I refer to Modification 9 of the approved Barangaroo Concept Plan recently submitted by the Central Barangaroo Developer.

Re: Submission MP06_0162 MOD 9 Barangaroo Concept Plan - OBJECT

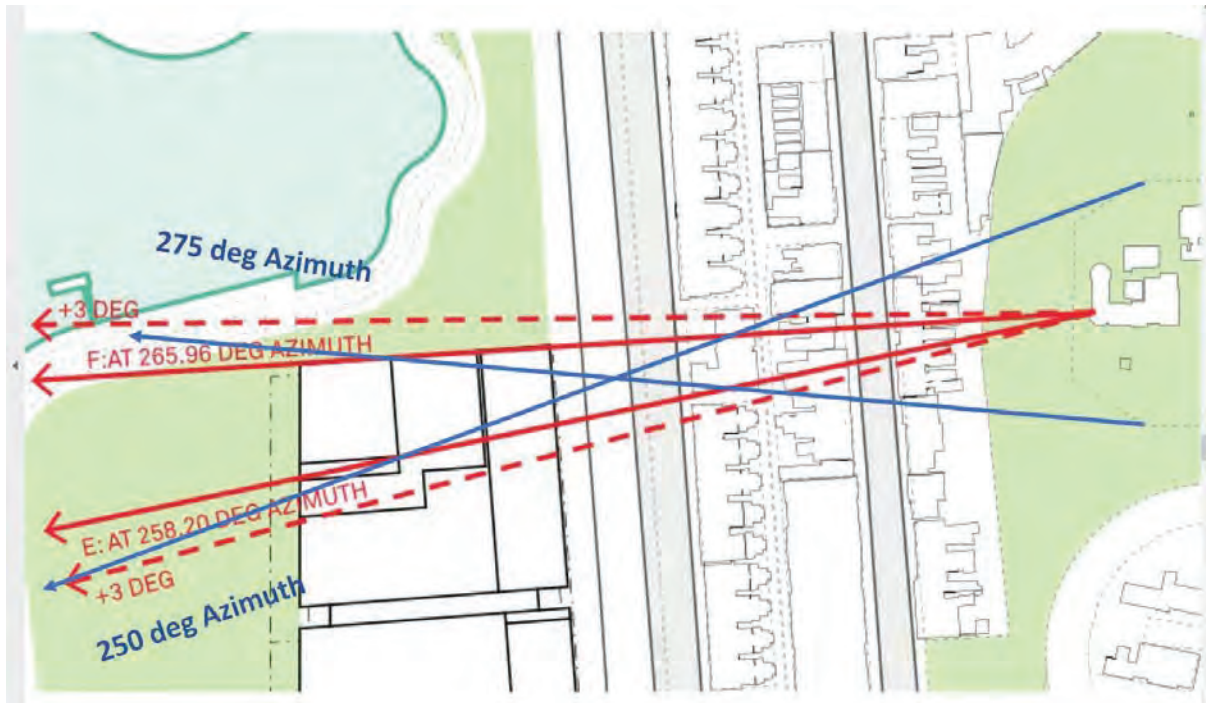
In fact, Sydney Observatory observes the western sky from its whole site, including the northern courtyard, the western driveway, the southern garden, etc. and does so using portable telescopes, binoculars and the naked eye. Measuring from Fig 1. (a modified copy of Fig 6, page 17 of the Unisearch report) we find the following azimuth angles for Block 7,

That is, Block 7 obstructs azimuths in the range of 250 to 275 degrees, not including any additional margin beyond the building envelope.

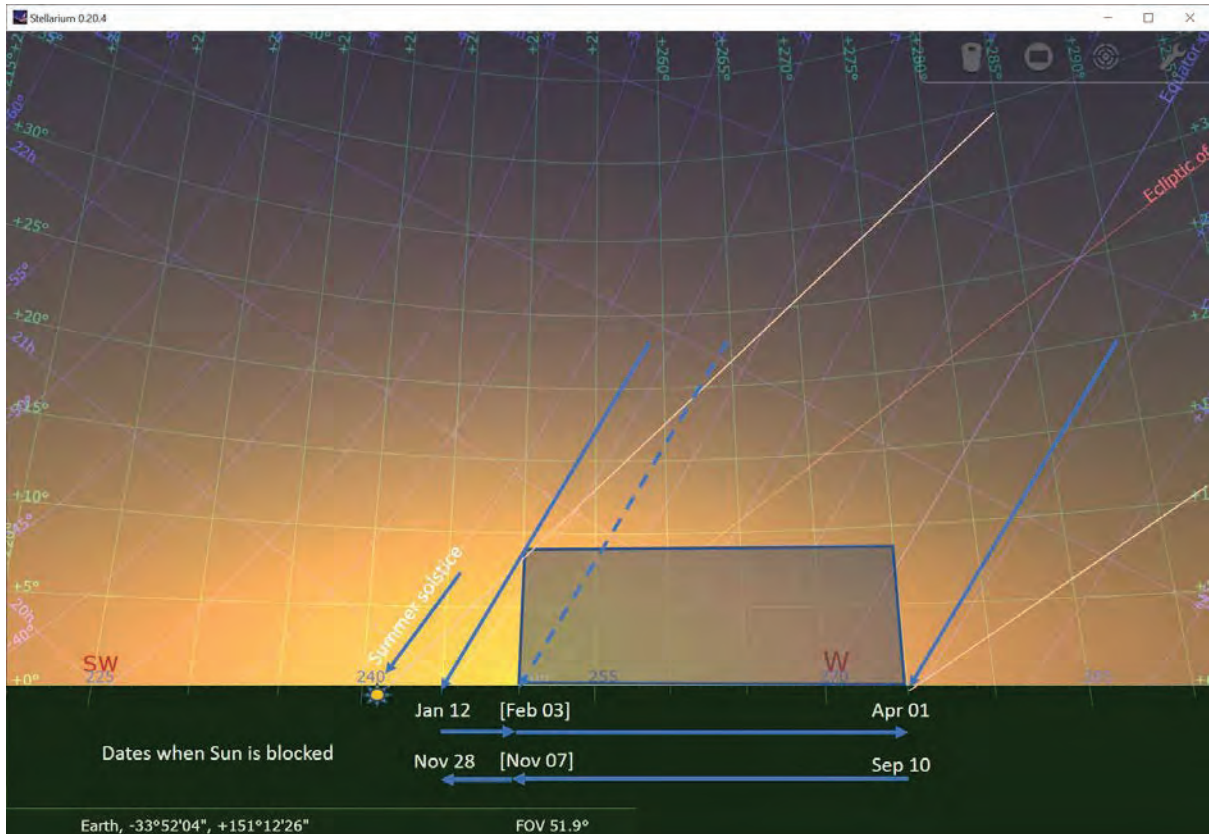
The Sun sets at azimuth 250-degrees on Feb03 and Nov07. The Sun sets at azimuth 275-degrees on Apr01 and Sep10. But as Fig 3 shows the corner of the obstruction also blocks views of the setting Sun (moving on an angled path in the sky) for additional days, from about Jan 12 and up to about Nov 28.

Fig. 9 The partial solar eclipse of 2030 Nov 25. Made with Stellarium.

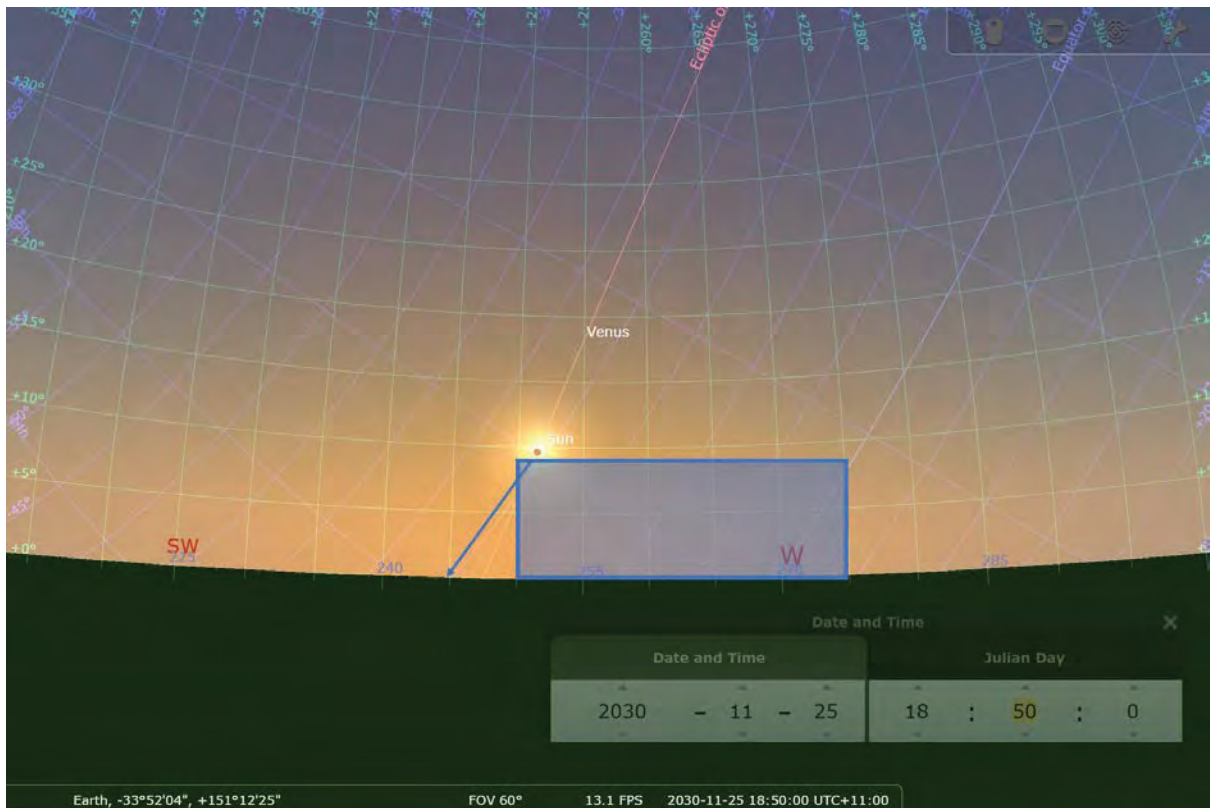
As Fig. 9 shows the eclipse is obstructed by Block 7 from 6:55pm until 7:02pm, interrupting this event.

Fig. 14 The Transit of Mercury of 2039 Nov 07. Made with Stellarium.

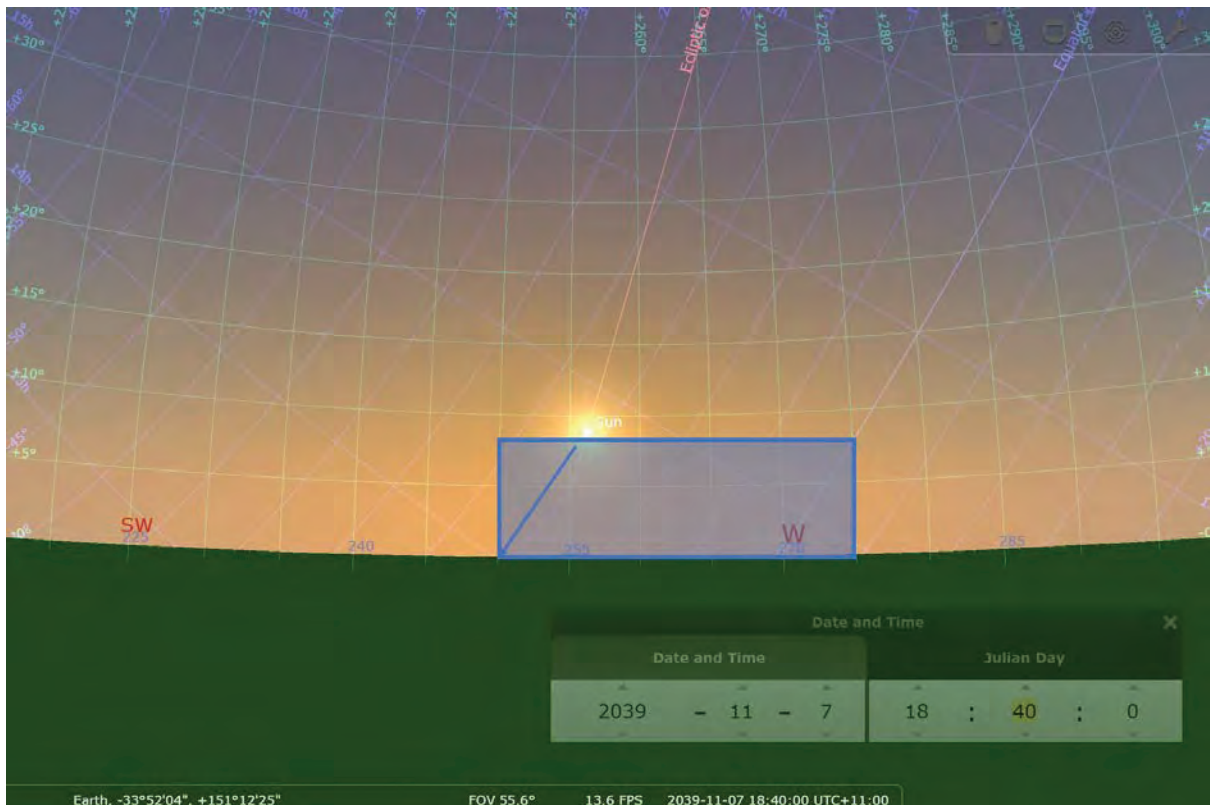
The event is obstructed by Block 7 from 6:45pm until 7:15pm, or for a quarter of the available viewing time.

Figure 35 MOD 9 building envelopes in the context of immediate surrounding development

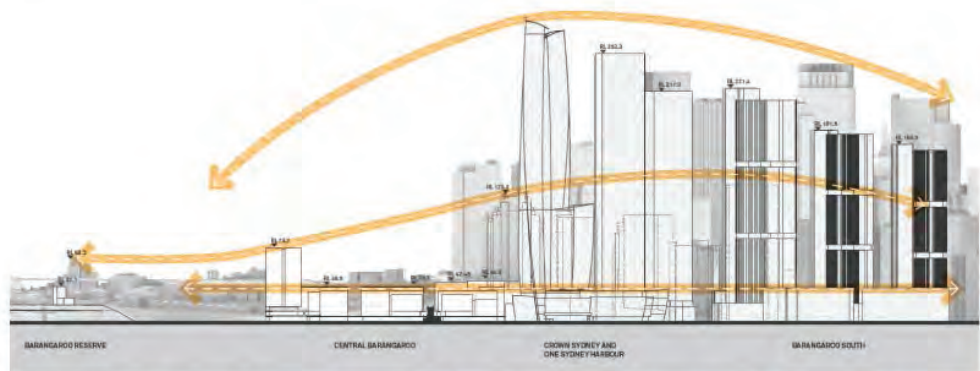
The diagram (Figure 35) illustrated on page 161 of the Environmental Assessment Report, purporting to illustrate the relationship of the existing and proposed built form is substandard as an explanation or justification of the urban proposition. These documents have statutory purpose - and documentation in them should meet a minimum professional standard.

The diagram (Figure 35) illustrated on page 161 of the Environmental Assessment Report, purporting to illustrate the relationship of the existing and proposed built form is wholly deficient as an explanation or justification of the urban proposition. These documents have statutory purpose - and documentation in them should meet a minimum intellectual standard.

Figure 14 Depiction of the indicative building envelopes, orientations and separations proposed for Central Barangaroo (Urbis, 2021a, p. 30)

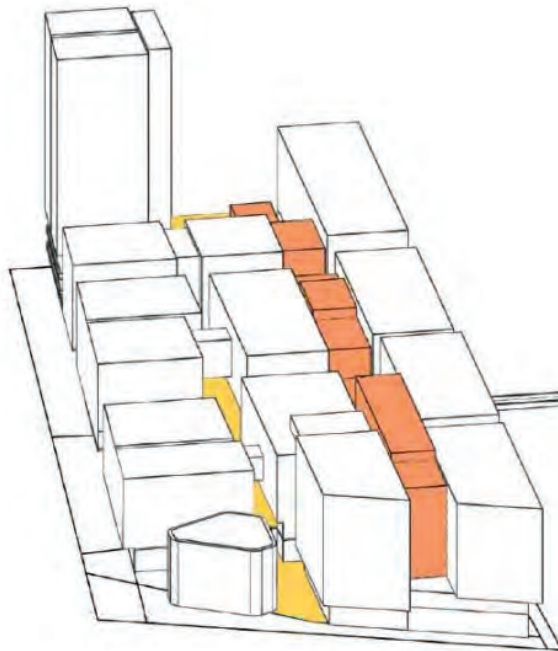
heights of the buildings, with devastating impacts. The Infrastructure NSW (Urbis, 2021) application concept bears little resemblance to the Concept Plan (MP06_0162), as is readily seen by comparing Figure 13 and Figure 14.

Figure 15 Proposed below ground retail within Central Barangaroo (Urbis, 2021, p. 154)

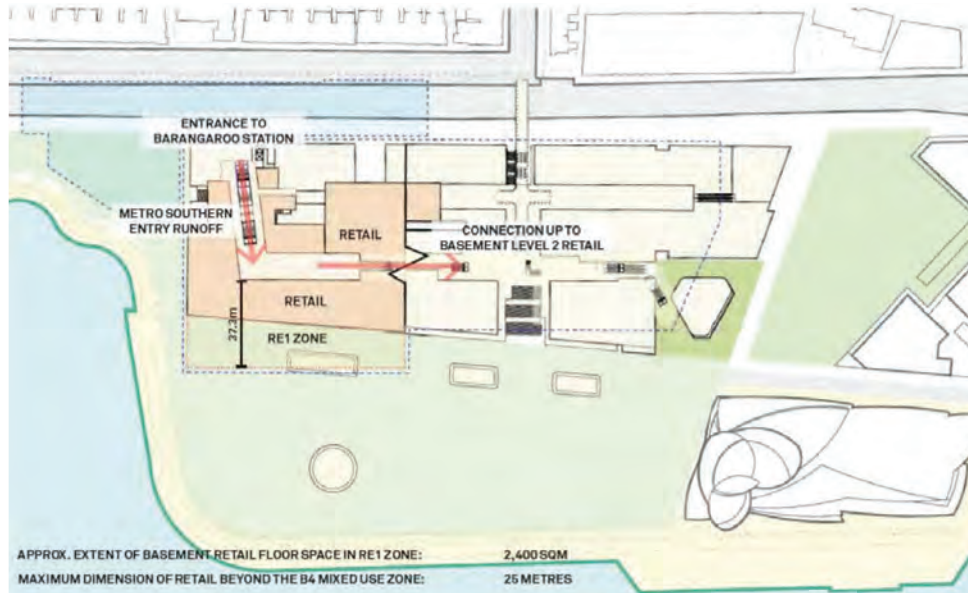
designed to a nominal depth of 15m below ground level (Urbis, 2021, p. 237), see Figure 15. There is no impact study or engineering report provided to assess the risks such development poses to the adjacent High Street cutting, heritage area and items, and local residential buildings.

Figure 29 Depictions of the mass and bulk of the proposed reinstated Block 5 (Hassell, 2021, p. 186)

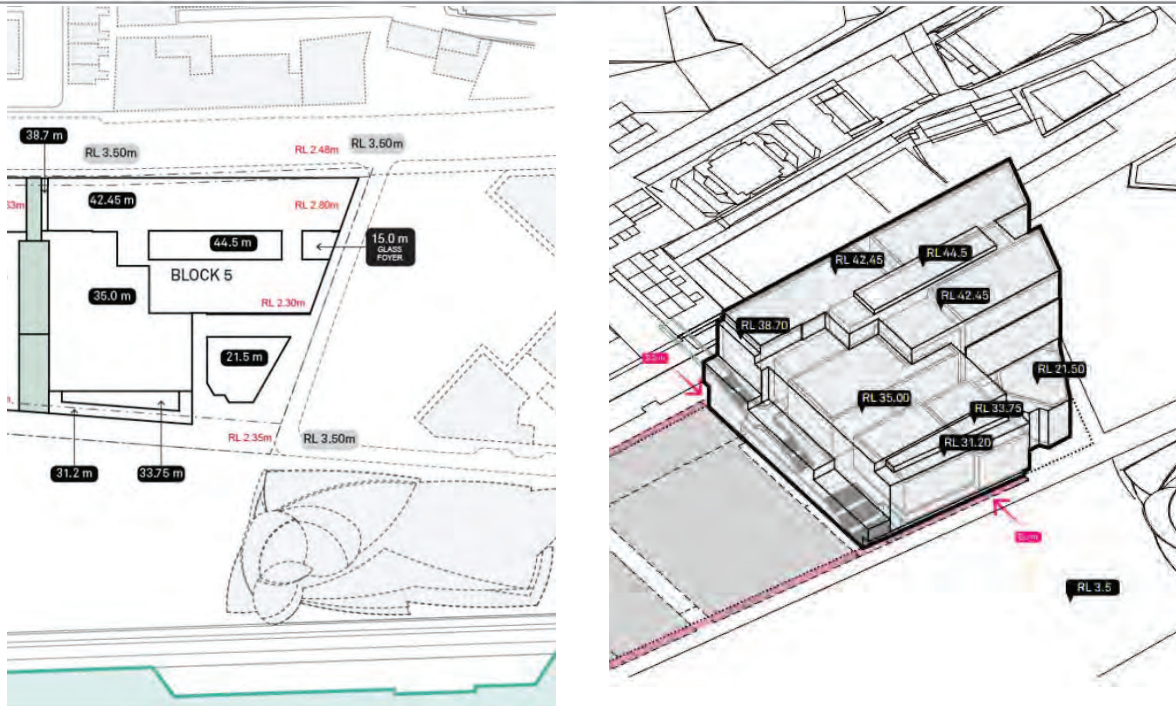
Infrastructure NSW refers to the reinstatement of the **Block 5** footprint, density, and envelope, as can be seen in Figure 29, as a 'realignment' or moving of the 'boundary'. This is deceptive. Such egregious manipulation is unacceptable from a NSW Government agency.

Figure 45 Notional intrusion of the built form of the 'Barangaroo Steps' into the green space of the parklands (Hassell, 2021, p. 52).

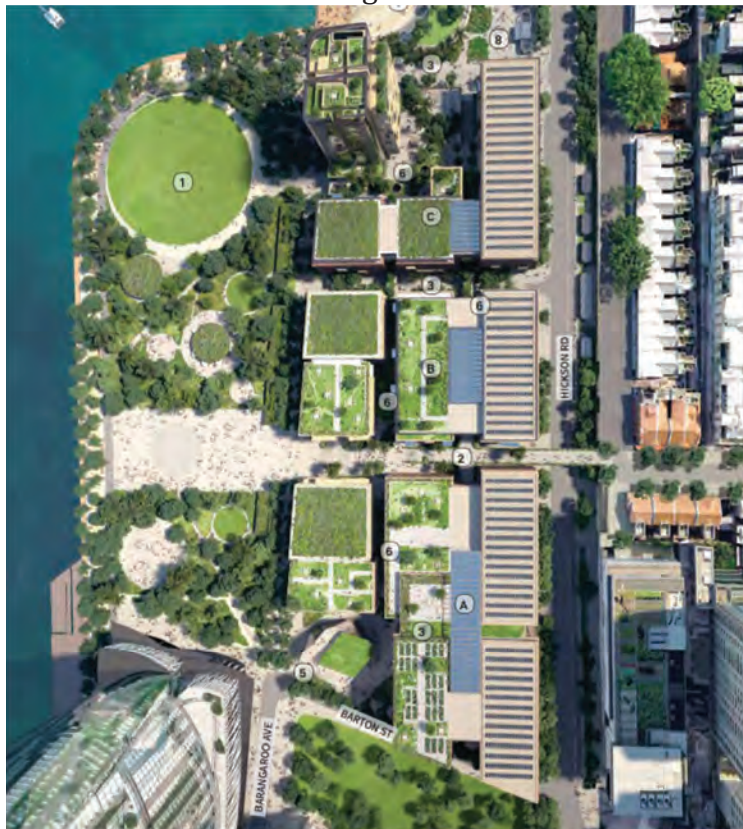
Infrastructure NSW presents the 'playfields' as primarily parkland and make a significant intrusion of built form into prized green space by the 'Barangaroo Steps' linking Central Barangaroo to High Street. This is shown in Figure 45.
